Work Order ID 84713

Item Name: Basket Hoop

DRAWING NO. D3166	TITLE BASKET HOOP	REV.A1	DART AEROSPACE LTD ENGINEERING ORDER		D.E.O. NO. D3166-A-2	SHEET NO. 1 OF 1	SCALE NTS
DRAWN AJS	CHECKED L	MFG. APPR. M	APPROVED MD		DE APPR. H		
DATE 08.12.11	DATE 08.12.15	DATE 08/12/15	DATE 08/12/16		DATE 08.12.16

DESIGN #	DRAWN BY CP	DART AEROSPACE LTD HAWKESBURY, ONTARIO, CANADA	
CHECKED #	APPROVED #	DRAWING NO. D3166	REV. A SHEET 1 OF 1
DATE 02.07.10		TITLE BASKET HOOP	SCALE NTS
A	02.07.10	NEW ISSUE	
A1	04.04.08	38+/-1 WAS 36.0

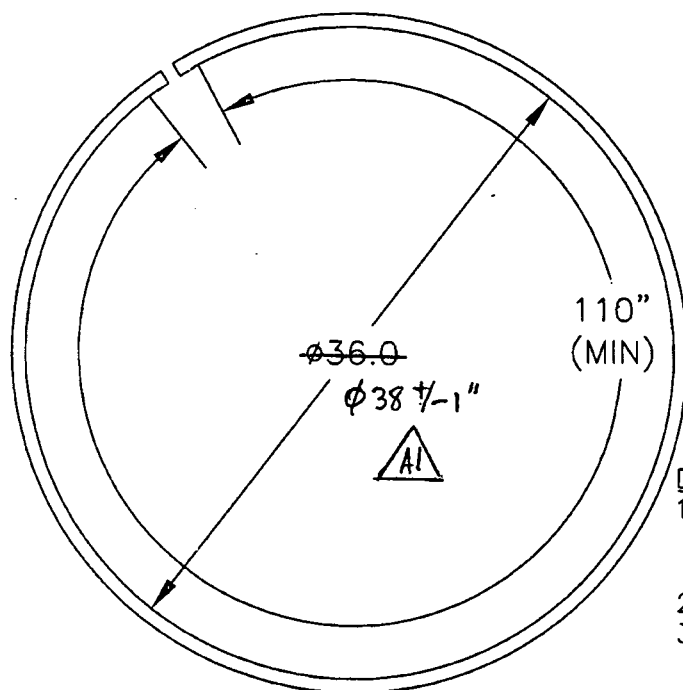
1) MODIFY MATERIAL NOTE FOR D3166-1 AS SHOWN:

2) MODIFY MATERIAL NOTE FOR D3166-3 AS SHOWN:

IS:

1) MATERIAL: AISI 304/316 SS, 3/4 X 3/4 X 0.065 WALL SQUARE TUBING,
60.00" LONG
REF. DART SPEC M304TS0.750W.065

IS:

1) MATERIAL: AISI 304/316 SS, 3/4 X 3/4 X 0.065 WALL SQUARE TUBING,
120.00" LONG
REF. DART SPEC M304TS0.750W.065
